# 12-16 Bent Street, Lindfield

## Flood Impact Risk Assessment

## 4. Response to CPHR/DPHI RFI

Table 2 CPHR/DPHI RFI Response

**Drawing Title**  
CIVIL ENGINEERING SERVICES  
STORMWATER DETAILS - SHEET 2

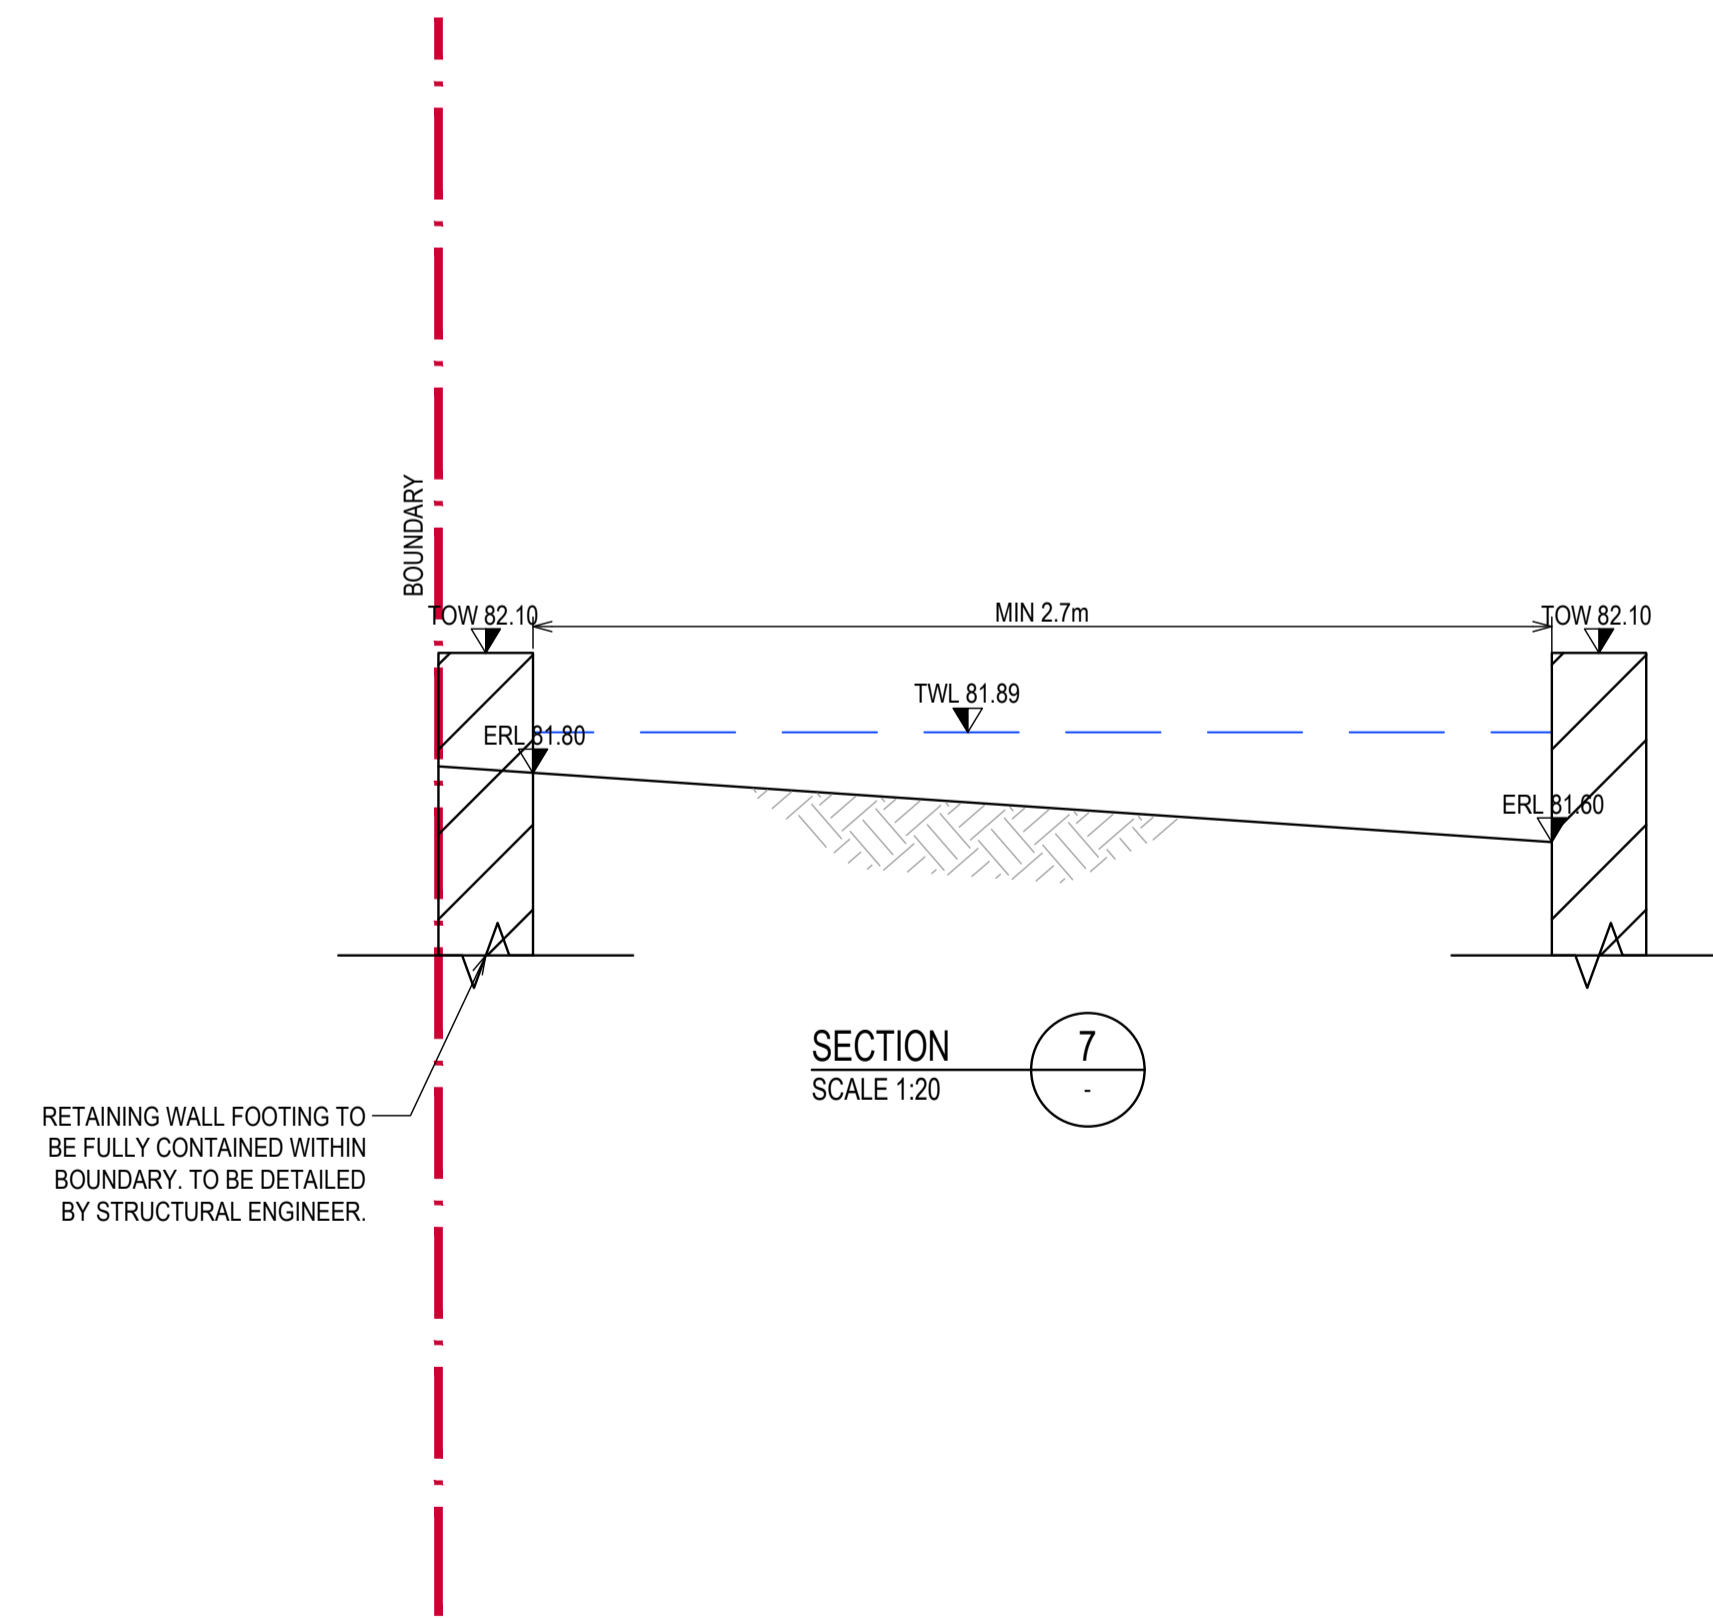
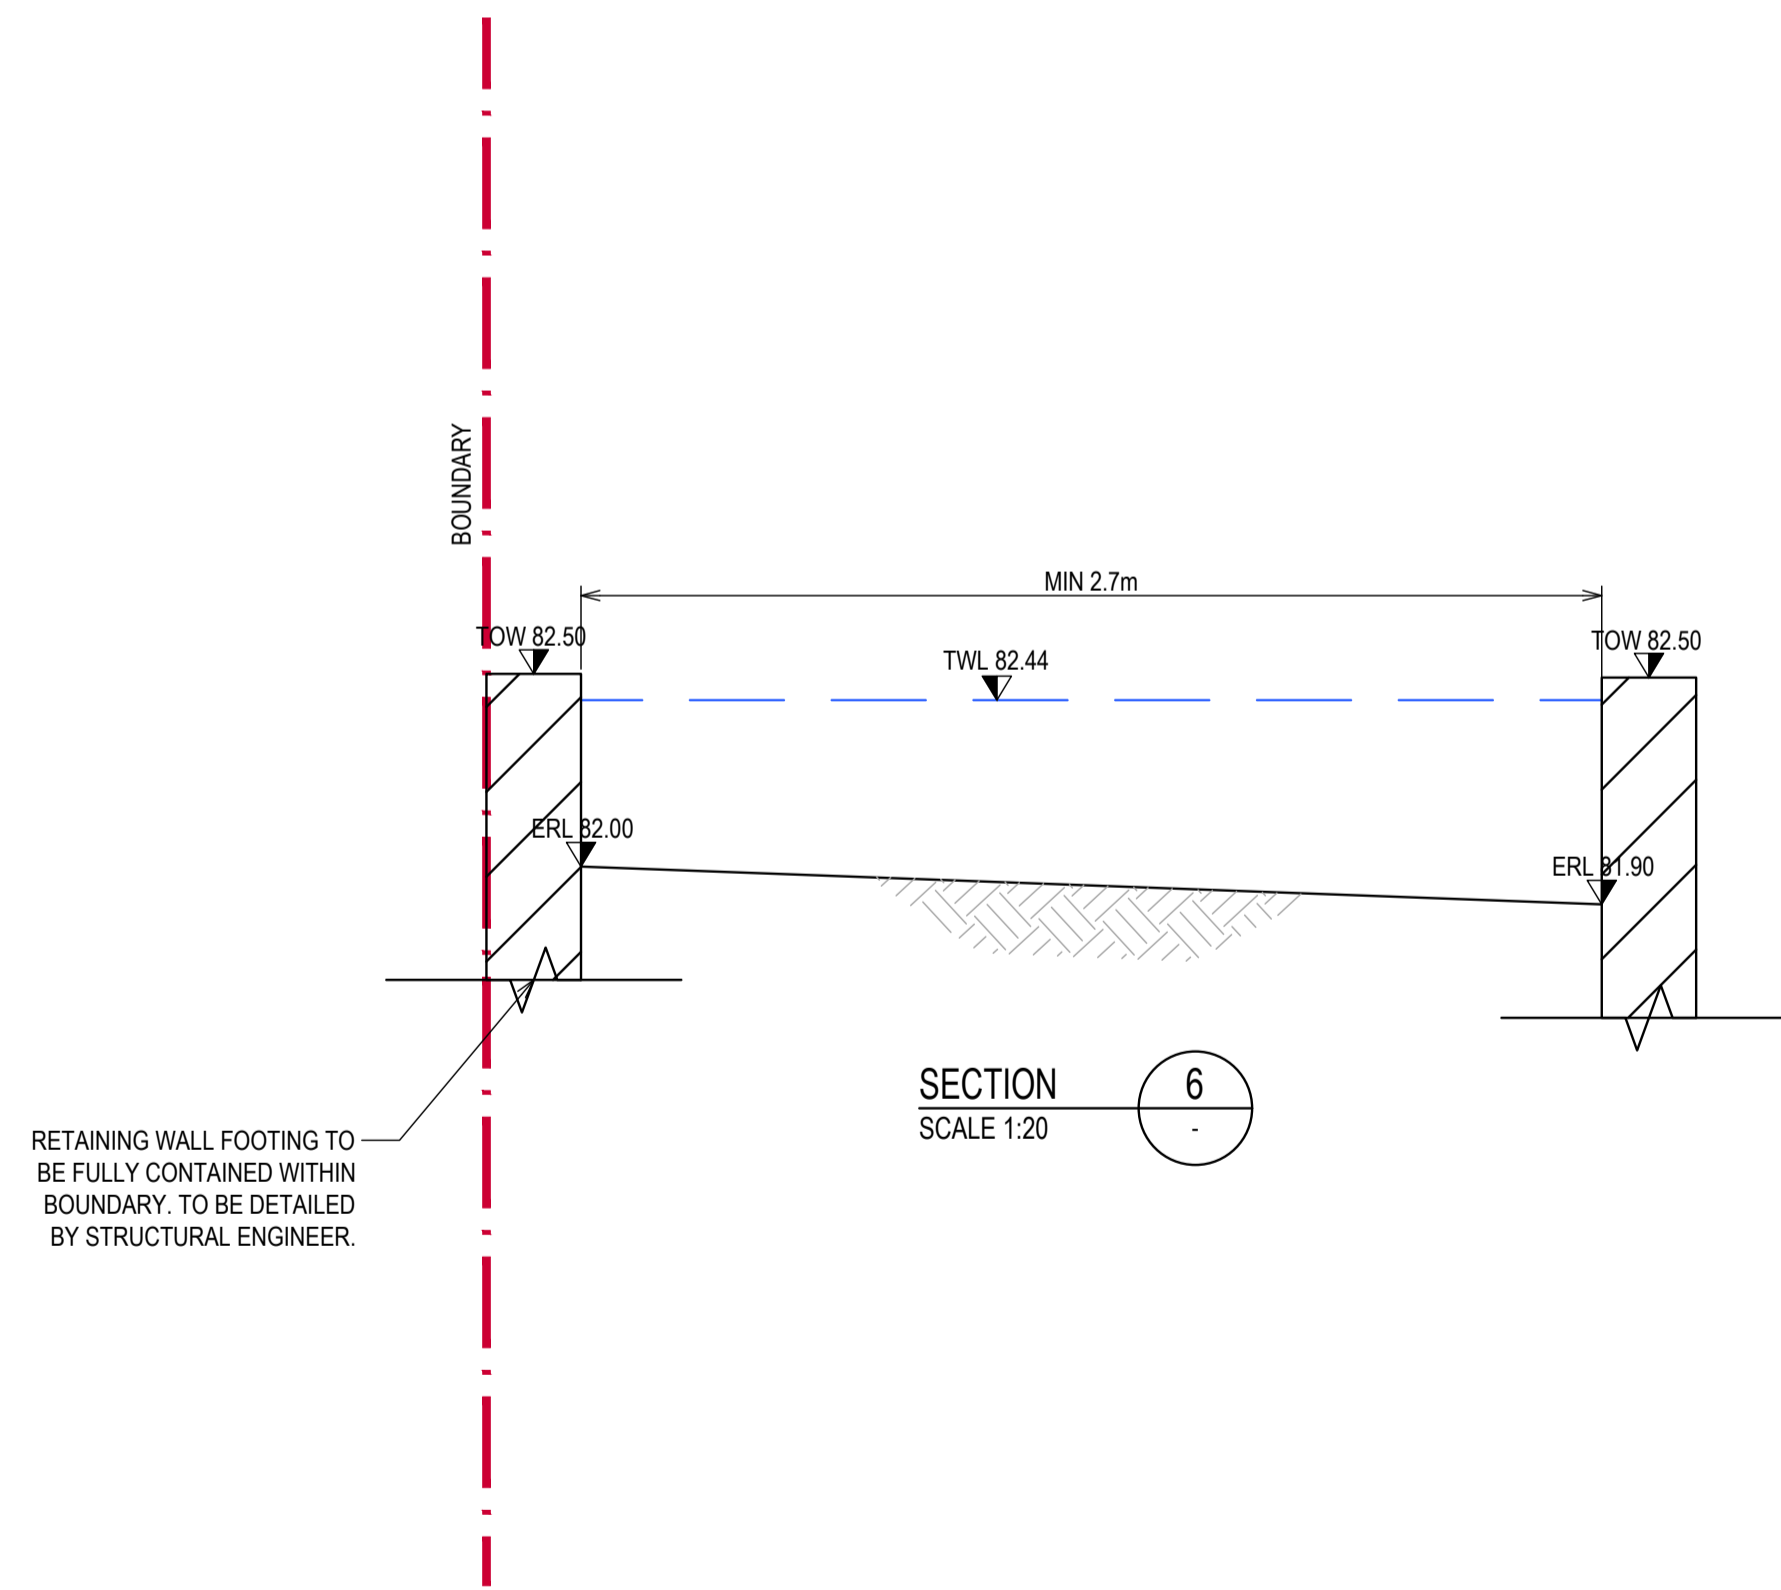
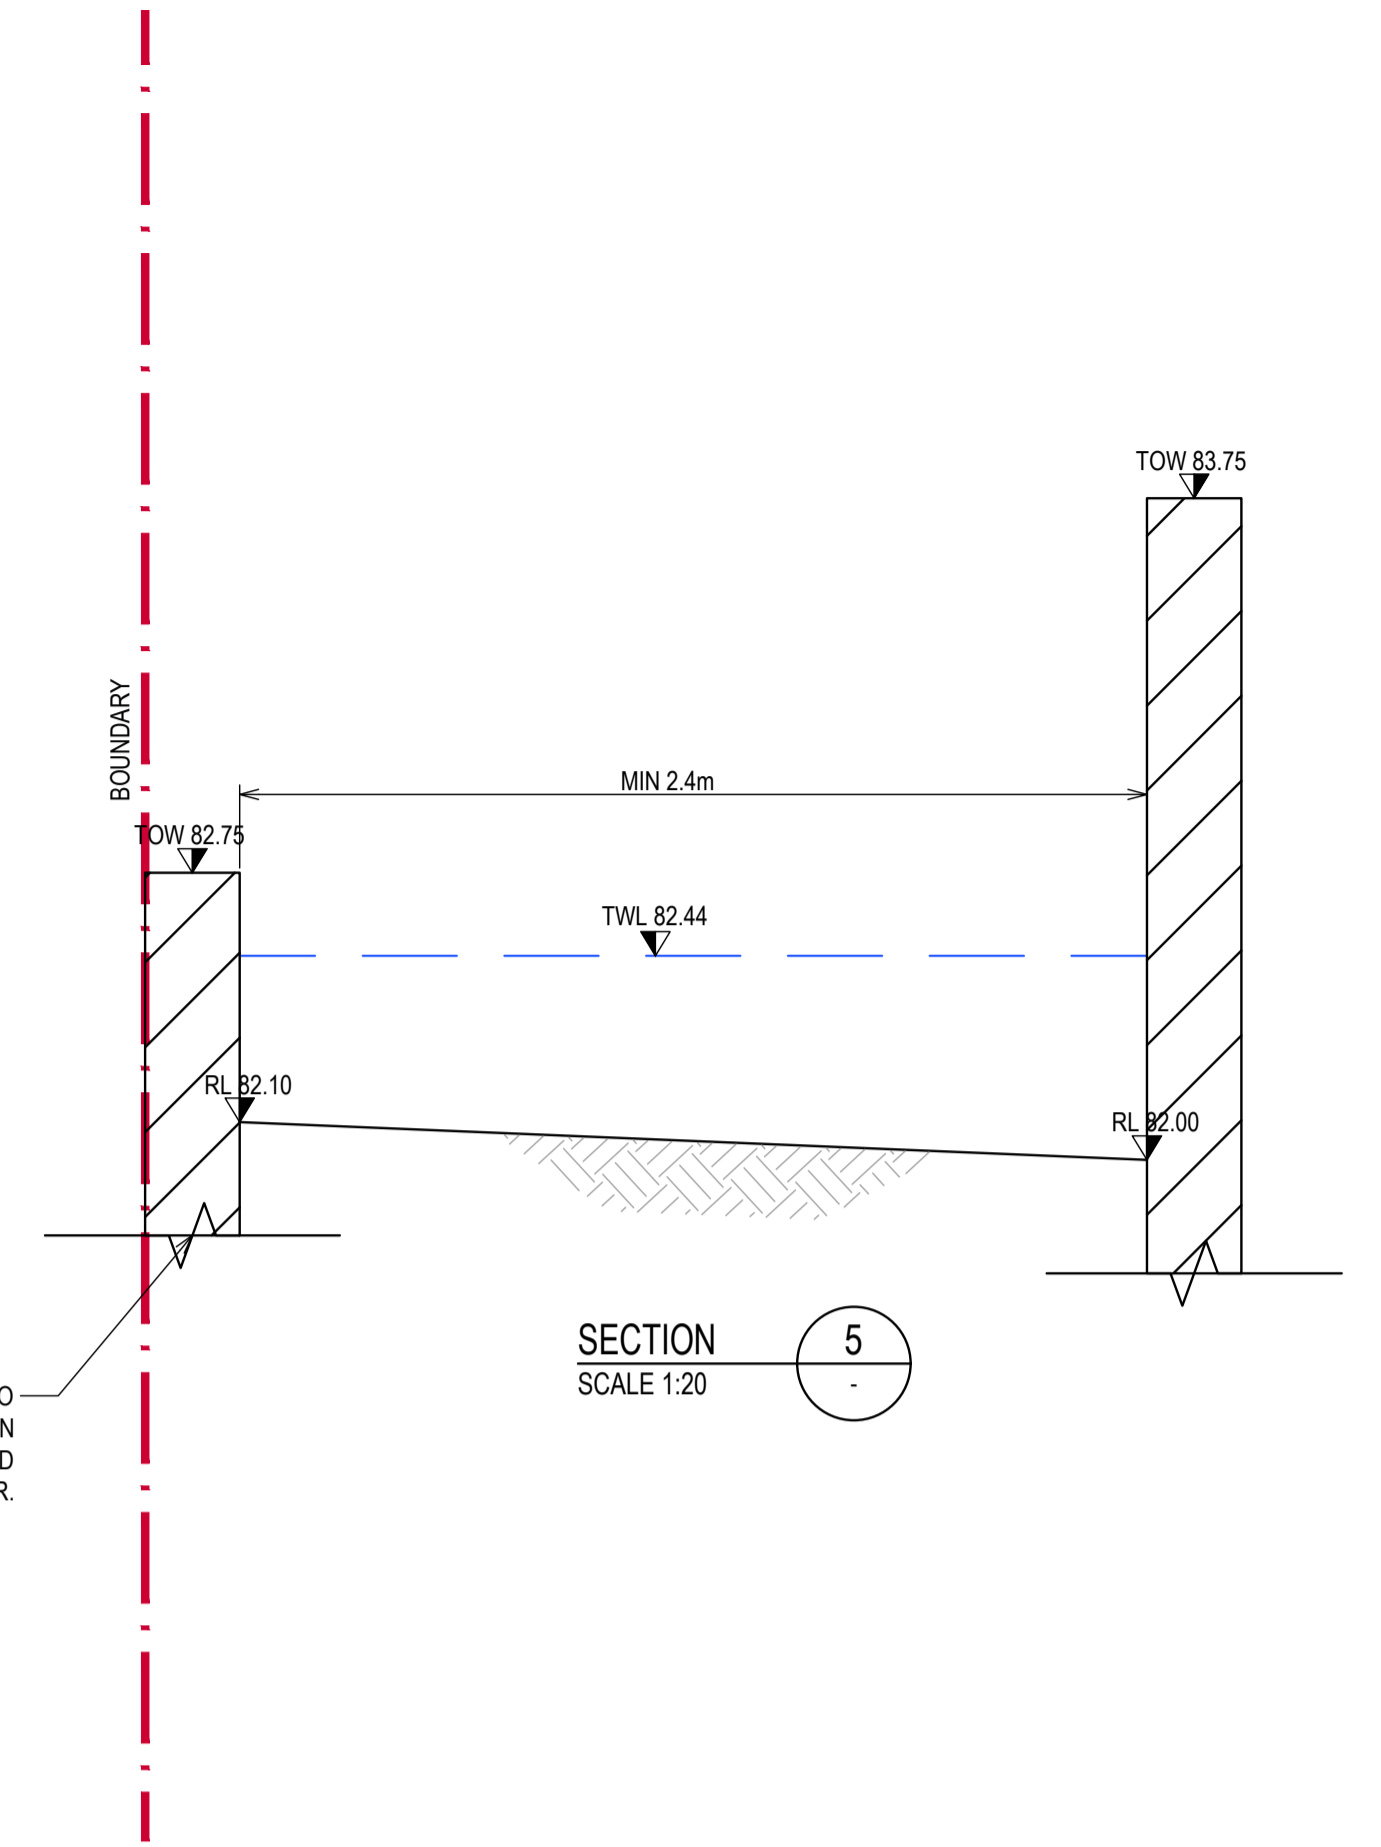
4.	The impact of climate change has not been considered	<p>The impacts of climate change on flood levels have not been modelled. Further, overland flow paths for the subject development are based on work undertaken for the neighbouring development that has been designed for the expected 1% Annual Exceedance Probability (AEP) flow in 2015 only and may not be adequate into the future.</p> <p><b>CPHR recommendation:</b></p> <ul style="list-style-type: none"> <li>• The impact of climate change on flood levels be included in the flood modelling</li> </ul>
	Extent and Timing	Pre-determination

Drawings CE201 and CE202 provide sectional views of the proposed overland flow path, including dimensions and water levels. As indicated in Drawing CE103, tree protection zones (TPZs) within the flow path make re-grading works impractical. Instead, it has been proposed for walls to be constructed to contain the runoff, with footings constructed to span over the TPZ.

4	<p>Climate change impacts have been modelled using the 2060 SSP2-4.5 scenario as part of this assessment and included as part of design considerations.</p> <p>Floodwaters are wholly contained within both the existing and neighbouring channels, with the exception of a single channel section in the adjoining property, where floodwaters overtop at depths &lt; 10mm.</p> <p><u>Refer to Section 2.2.2 and 2.4 for details.</u></p>
5	<p>The proposed overland flow path has been modelled using a 1D analysis of channel cross-sections that accurately represents the proposed geometry and vegetation.</p> <p>Proposed retaining walls have been shifted to sit entirely within the proposed site boundary.</p> <p><u>Refer to Section 2.3.3, 2.4 and Appendix E for details.</u></p>
